# STAFF RECOMMENDATION

NCPC File No. 7214

## NATIONAL ZOOLOGICAL PARK NORTH ROAD RETAINING WALL

February 24, 2011

**Proposed Retaining Wall Elevations**

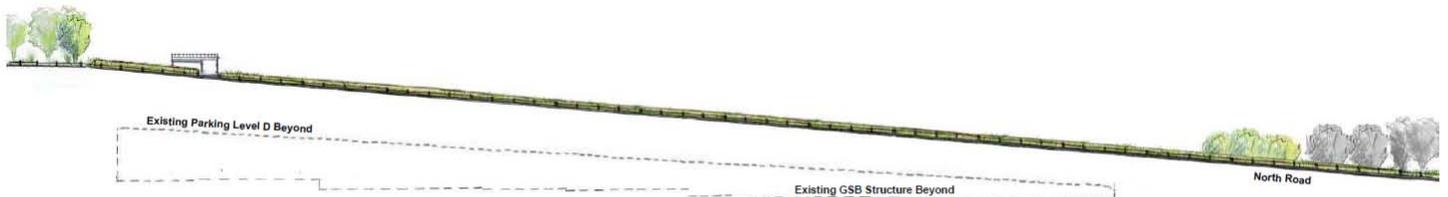
According to the submission documents, the proposed project will remove the hillside vegetation comprised of various native and invasive deciduous woodland tree species, understory shrubbery, and groundcover; approximately 100 existing trees would be removed. Staff recommends that the Smithsonian Institution evaluate ways to replace the trees lost due to construction as they move forward with the project's landscape plans. The Federal and District Elements of the Comprehensive Plan for the National Capital and the District government include policies that encourage the preservation of trees and the increase of the District's tree canopy. Opportunities to intensify the vegetation adjacent to the project site to minimize views of the retaining wall from Rock Creek Park and adjacent roadways should be evaluated. Furthermore, staff encourages the Smithsonian Institution to continue consultation with the National Park Service to ensure the protection of the natural qualities of Rock Creek Park.

The Smithsonian Institution has submitted current views of the project site from various locations including along Adams Mill Road and the Rock Creek Trail. The photos, taken in winter season, indicates that there will be minimal views of the retaining wall due to vegetation and the earthen berm; however, staff requests that the Smithsonian submit photo simulations of the proposed retaining wall to permit an evaluation of the effects of the retaining wall. Views along Beach Drive are especially important to understand as it is the roadway directly adjacent to the General Services Building and has the most potential to be affected by the project.

- Evaluate ways to replace the tree canopy lost due to the construction;
- Evaluate opportunities to screen views of the retaining wall from Rock Creek Park; and
- Continue consultation with the National Park Service to ensure preservation of the natural quality of Rock Creek Park.

- Detailed landscape plans; and
- Massing views of the proposed retaining wall from Beach Drive, points along Adams Mill Road, and the Rock Creek Trail.
